Intel® Mobile Celeron™ Processor Specification Update

Release Date: 25 January 1999

Order Number: 244444-001

Figure 1. An Example of Microcontroller Driven Thermal Management

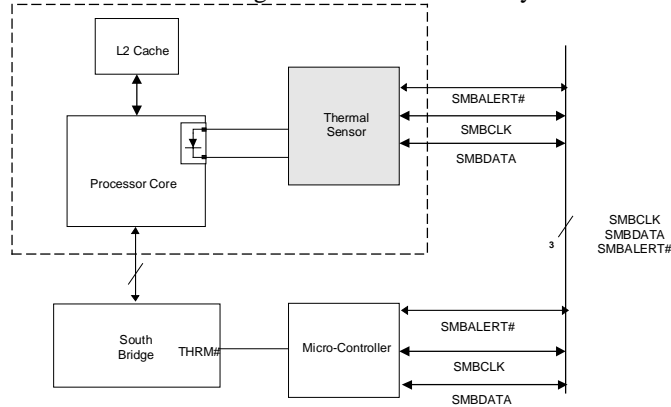
PROBLEM: The Intel® Mobile Celeron™ Processor Mobile Module has a thermal sensor that monitors the processor core's temperature. Please note that desktop systems could have a similar

thermal device. The thermal sensor asserts SMBALERT# if the processor temperature exceeds the temperature limits set in the Alarm Threshold Registers (T_{HIGH} , T_{LOW}). It also sets the corresponding Status Register bits to identify the cause of the interrupt. Figure 1 gives one example of the how the SMBALERT# signal could be used in a system.

Under the conditions described below, the thermal sensor incorrectly generates the SMBALERT# interrupt. *All* of the following conditions must be met to trigger a false interrupt:

1. Before servicing an interrupt from the thermal sensor, read and compare the processor thermal reading with the threshold limits (T_{HIGH} or T_{LOW}). Figures 2 and 3 provide basic flowcharts for the implementation of this workaround in an interrupt driven system.
2. If the firmware implemented polls the Status Register only, then before taking any action, re-read the temperature register and do a comparison with the alarm threshold limits (T_{HIGH} or T_{LOW}) to determine if the value is actually still within the temperature window.

- Use a temperature polling scheme to monitor the processor temperature.
